PROPOSED TECHNICAL SPECIFICATION CHANGES

MARKUP OF CURRENT ANO-1 TECHNICAL SPECIFICATIONS

ANO-1 CYCLE 13 COLR

ENTERGY OPERATIONS
ARKANSAS NUCLEAR ONE - UNIT ONE
CYCLE 13
CORE OPERATING LIMITS REPORT

~~Core Protection Safety Limits~~ ANO-1
~~Figure 2.1-3~~

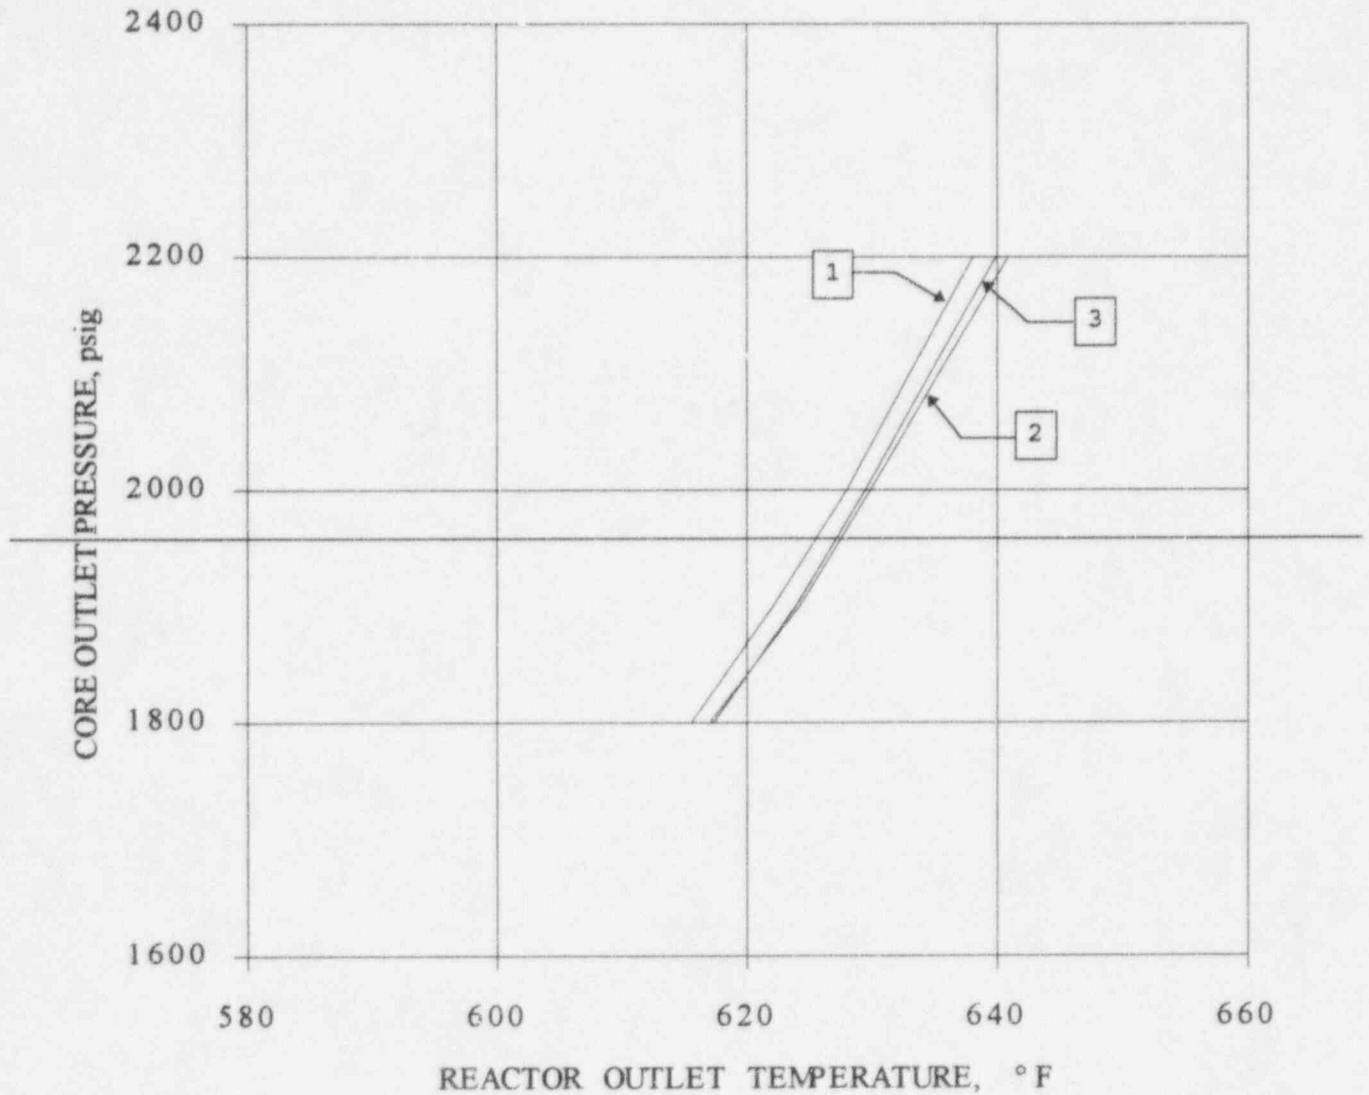
The ~~curve of Figure 2.1-1~~ Variable Low RCS Pressure-Temperature Protective Limit for four reactor coolant pumps operating is the most restrictive of all possible reactor coolant pump maximum thermal power combinations as specified shown in Figure 2.1-3 the COLR. The ~~curves of Figure 2.1-3~~ Variable Low RCS Pressure-Temperature Protective Limits in the COLR represent the conditions at which the DNBR limit is predicted at the maximum possible thermal power for the number of reactor coolant pumps in operation. If the actual pressure/temperature point is below and to the right of the pressure/temperature line, the ~~Safety~~ Variable Low RCS Pressure-Temperature Protective Limit is exceeded. The local quality at the point of minimum DNBR is less than 22 percent (BAW-2)(1) or 26 percent (BWC)(2).

Using a local quality limit of 22 percent (BAW-2) or 26 percent (BWC) at the point of minimum DNBR as a basis for curves 2 and 3 less than four reactor coolant pumps operating of Figure 2.1-3 the Variable Low RCS Pressure-Temperature Protective Limits specified in the COLR is a conservative criterion even though the quality at the exit is higher than the quality at the point of minimum DNBR.

For each curve combination of operating reactor coolant pumps of Figure 2.1-3 the Variable Low RCS Pressure-Temperature Protective Limits specified in the COLR, a pressure-temperature point above and to the left of the curve would result in a DNBR greater than 1.30 (BAW-2) or 1.18 (BWC) or a local quality at the point of minimum DNBR less than 22 percent (BAW-2) or 26 percent (BWC) for that particular reactor coolant pump situation combination. Curve 1 of Figure 2.1-3 The Variable Low RCS Pressure-Temperature Protective Limit for four reactor coolant pumps operating is the most restrictive because any pressure-temperature point above and to the left of this curve will be above and to the left of the other curves.

~~Figure 2.3-1~~

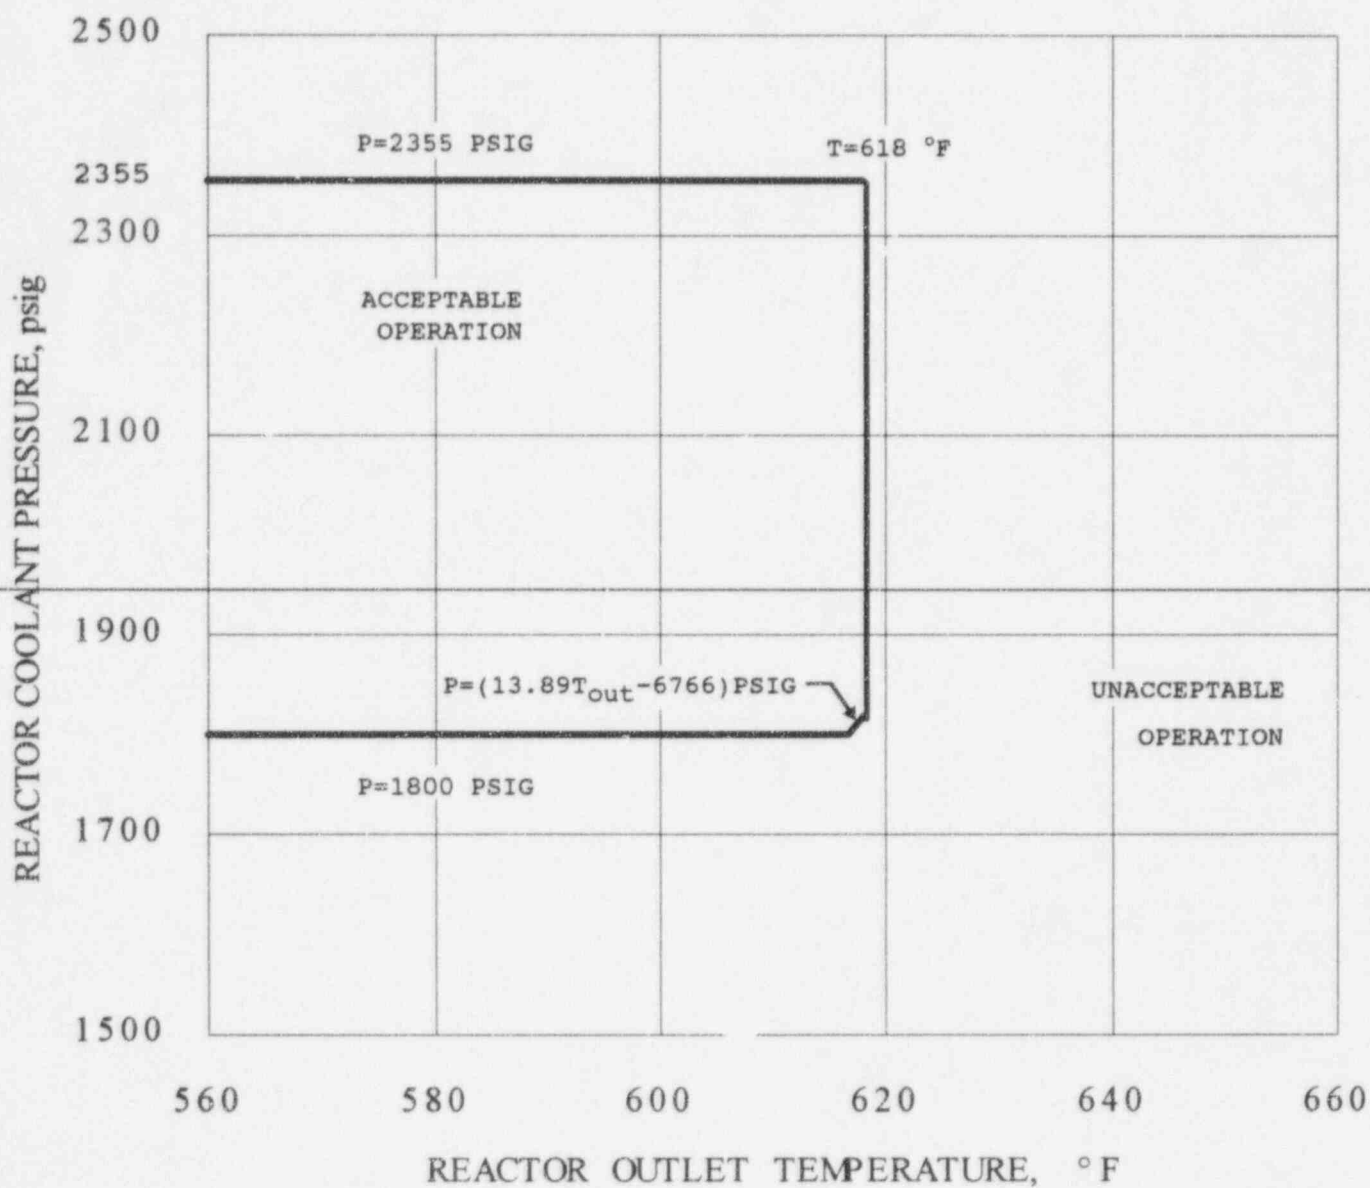
During a startup accident from low power or a slow rod withdrawal from high power, the system high pressure trip is reached before the nuclear overpower trip setpoint. The trip setting limit shown in Figure Table 2.3-1 for high reactor coolant system pressure (2355 psig) has been established to maintain the system pressure below the safety limit (2750 psig) for any design transient.⁽²⁾

The low pressure (1800 psig) and variable low pressure ~~(13,897_{out} - 6766)~~ (COLR) trip setpoint shown in Figure Table 2.3-1 have been established to maintain the DNB ratio greater than or equal to the minimum allowable DNB ratio for those design accidents that result in a pressure reduction.^(2,3)

Figure 10 Variable Low RCS Pressure-Temperature (P-T) Protective Limits

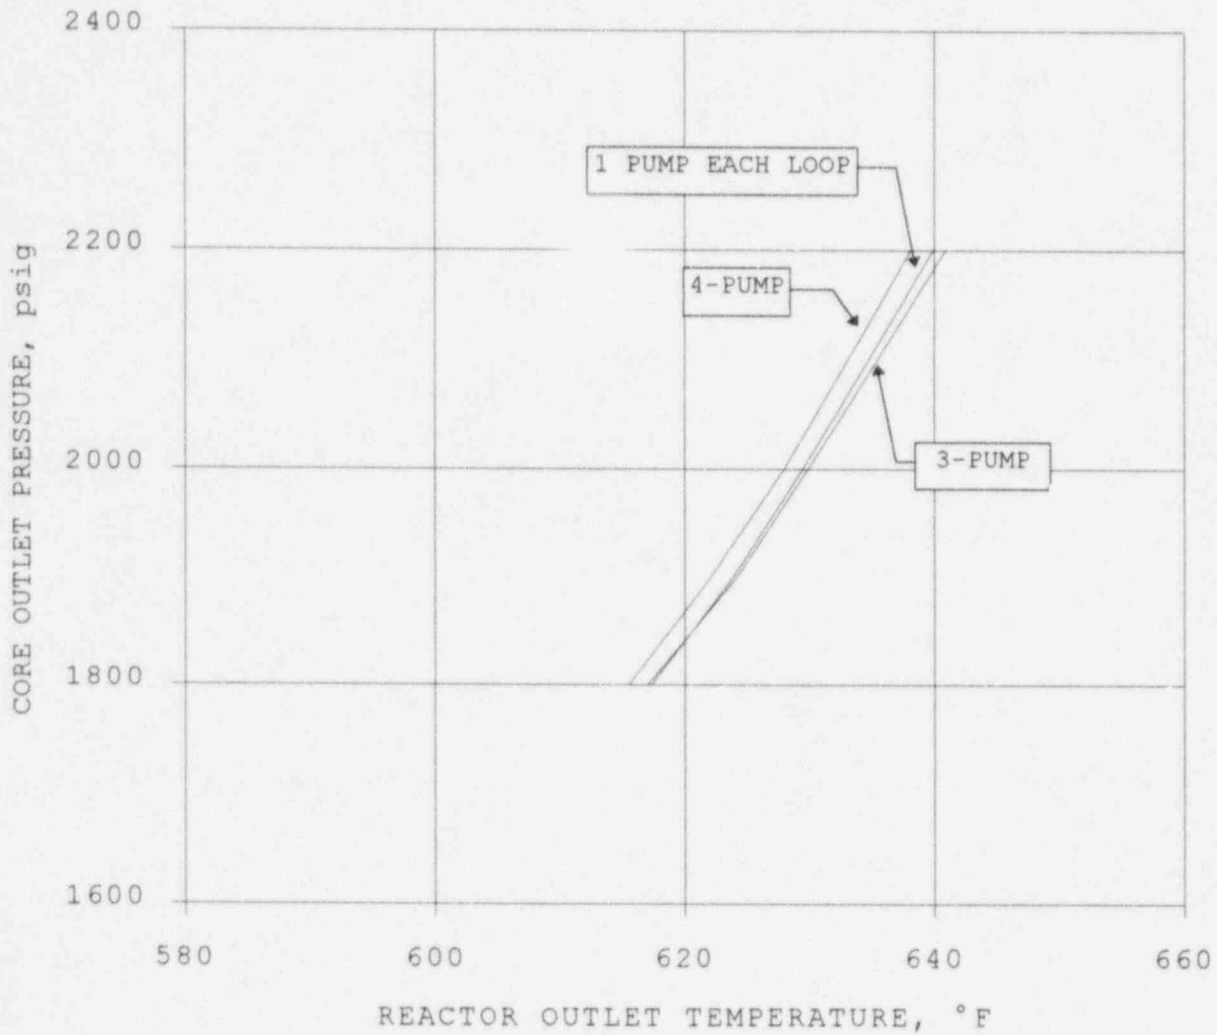
Figure is referred to by
Technical Specification 2.1.3

Figure 11 RCS Pressure-Temperature Protective Maximum Allowable Setpoints

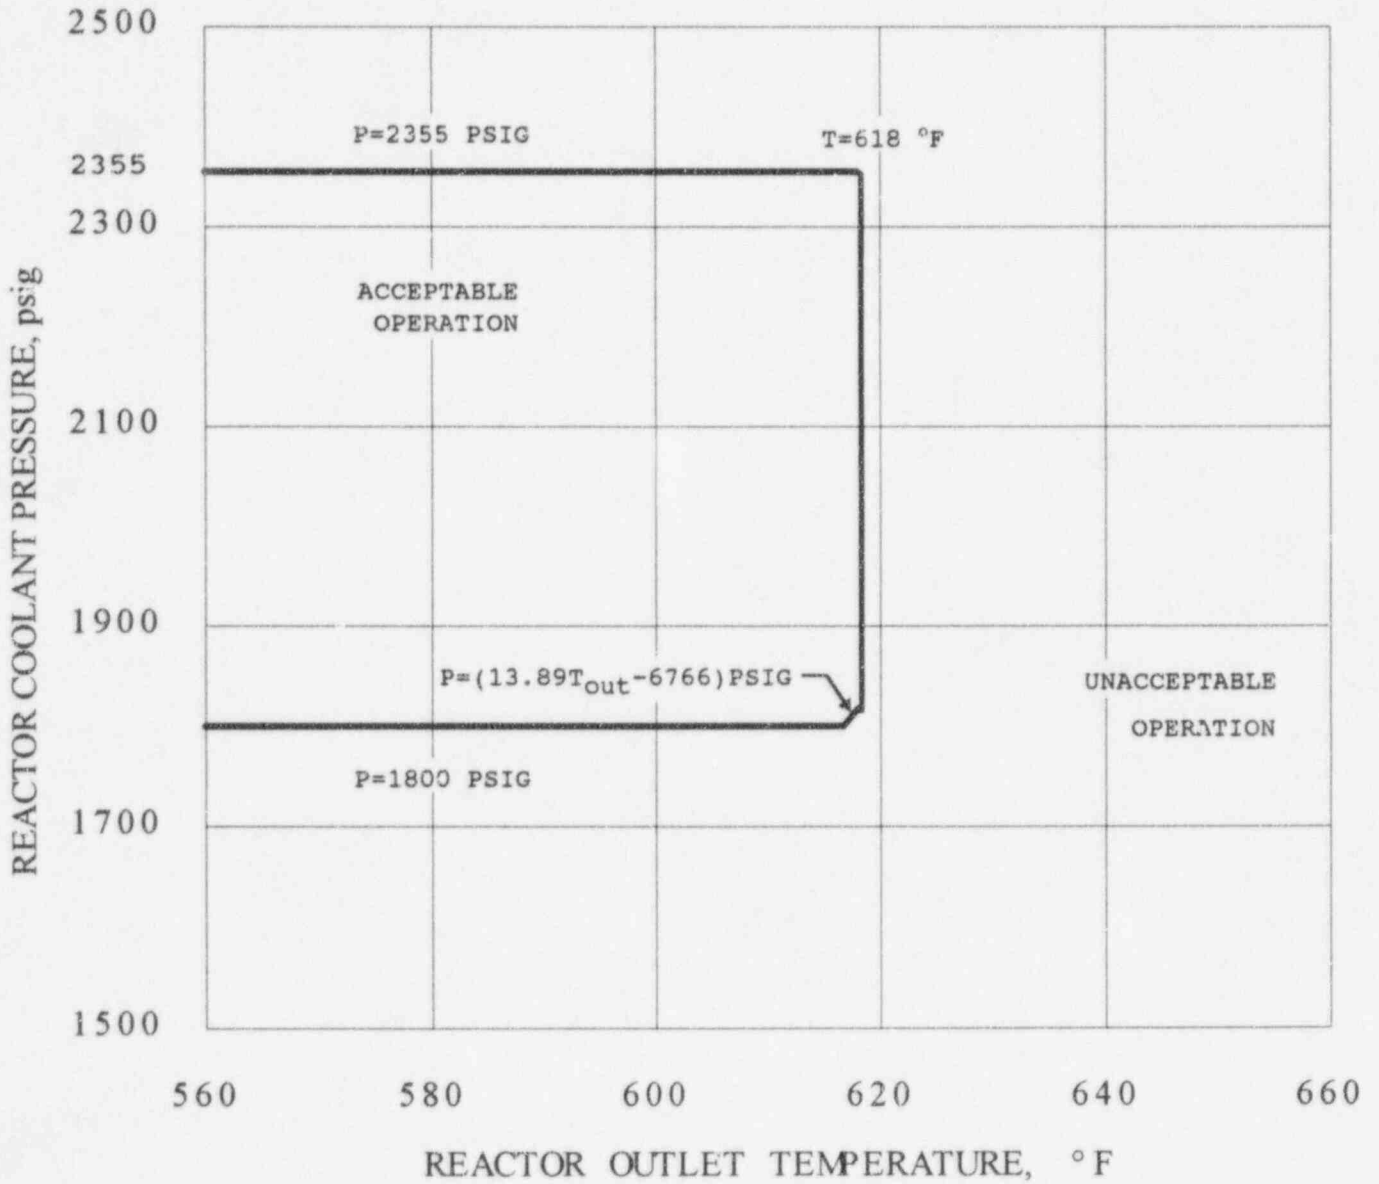
Figure is referred to by
Technical Specification Table 2.3-1
